Reference: JH / 12690 – 09.08.2021

LLFA Objection – Condition 2

Reference: RE: 6/2021/0505/COND – H R Owen. Mosquito Way, Hatfield, AL10 9WN

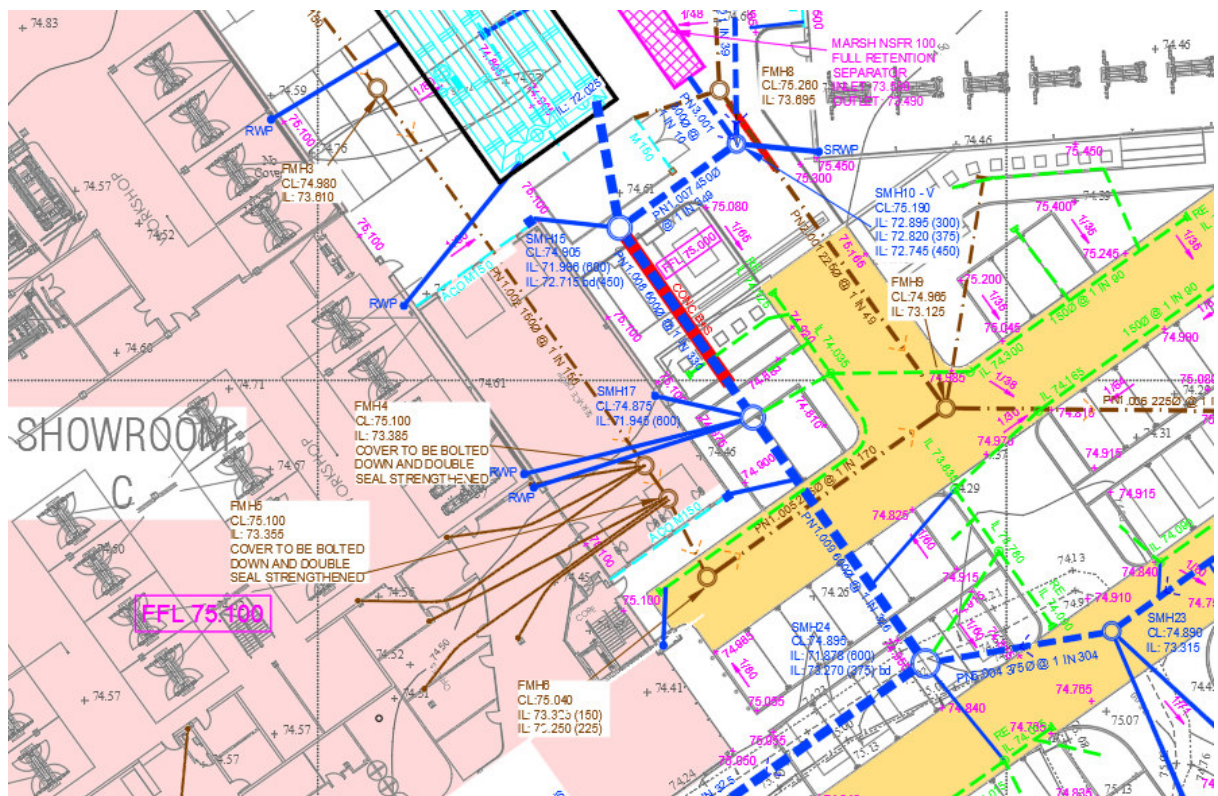
We would like to remind that no surface water drainage should be provided beneath a building. The applicant had clarified this and states that the storm run between SMH15 and SMH17 is not under a building, however the Landscape General Arrangement Plan indicates a form of structure/building here. Please could this be clarified. The drainage run between SMH15 and SMH17 is not beneath the building. The extent of building is shown in a pink hatch within the below screenshot.

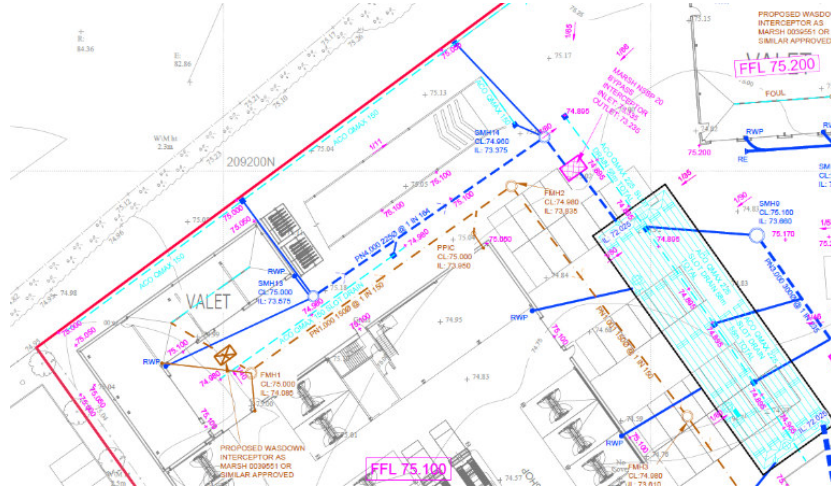
In addition, in the north western part of the site we have noticed that rainwater pipes are proposed to discharge at flood level. We would like to advise that appropriate connections into the wider network should be provided. No discharge to impermeable surface will be allowed. This is an old reference and is not shown on the latest drainage plan. No roof water is discharging to floor level. Screen shot shown below.
